Clarification Register: HCT/10/13/1164 TNPA993: The Design, Supply and Construction of Jockey and Booster Pumps and Associated Mechanical, Electrical and Civil Works for the CFI Project in Island View Complex – Port of Durban

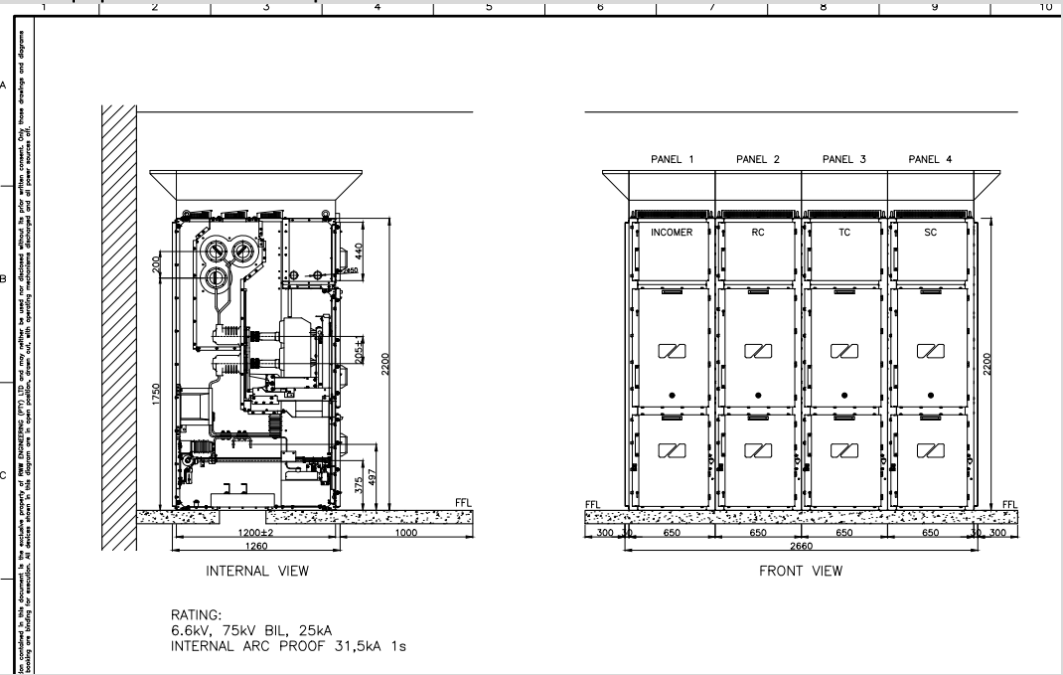
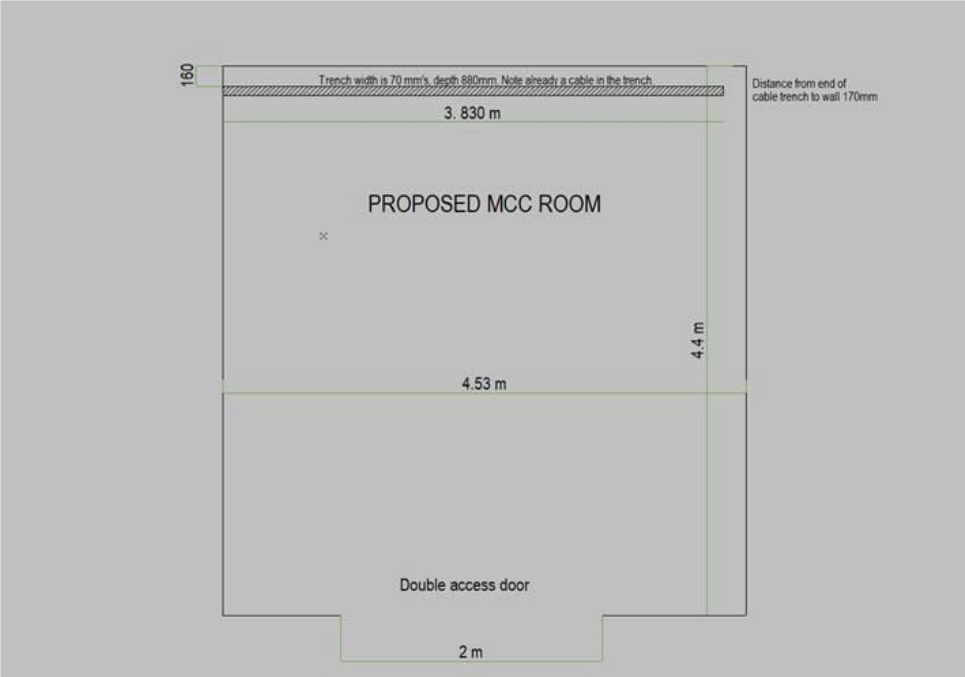
150NB Fibre Cement Lined piping (External to pump house underground) - 150NB pipe = 35m - 150NB Flanges = 0 off (Number of Flanges indicates welding? Or is this an error?) - 150NB Bends = 5 off		The item being queried is being reviewed by the project team and further clarification or an addendum will be issued in due course. Revised – 9.02.2022 – Addendum will be issued – Addendum 002 The majority of the piping will be welded and longer sections (12m) can be connected with the internal cement lining. The BOQ was adjusted to reflect the number of flanges anticipated. The detailed pipe design will be done before construction. Revised – 16.02.2022 Retracted – 28.02.2022 The item being queried is being reviewed by the project team and further clarification or an addendum will be issued in due course.
			150NB Fibre Cement Lined piping (External to pump house encased) - 150NB pipe = 20m - 150NB Flanges = 4 off (Number of Flanges indicates welding? Or is this an error?) - 150NB Bends = 3 off		The item being queried is being reviewed by the project team and further clarification or an addendum will be issued in due course. Revised – 9.02.2022 – Addendum will be issued The BOQ was adjusted to reflect the number of flanges anticipated. The detailed pipe design will be done before construction. Revised – 16.02.2022 - Addendum was issued – item 7.1.55; 7.1.56 and 7.1.57 The majority of the piping will be welded and longer sections (12m) can be connected with the internal cement lining.

Not Indicated on below drawing 150NB Fibre Cement Lined piping (External to pump house Above ground) (where is there above ground piping besides leading in and out of the Pump house? Where is the 250NB line then?) - 150NB pipe = 6m - 150NB Flanges = 0 off (Number of Flanges indicates welding? Or is this an error?) - 150NB Bends = 3 off		The item being queried is being reviewed by the project team and further clarification or an addendum will be issued in due course. Revised – 9.02.2022 – Addendum will be issued The BOQ was adjusted to reflect the number of flanges anticipated. The detailed pipe design will be done before construction. The above ground 205NB line is between the manhole and the new jockey and booster pump station as shown on drawing 2123421-1-000-M-LA-0001-01-0F Revised – 16.02.2022 - Addendum 002 was issued – item 7.1.55; 7.1.56 and 7.1.57 The majority of the piping will be welded and longer sections (12m) can be connected with the internal cement lining. The above ground 205NB line is between the manhole and the new jockey and booster pumpstation as shown on drawing 2123421-1-000-M-LA-0001-01-0F.
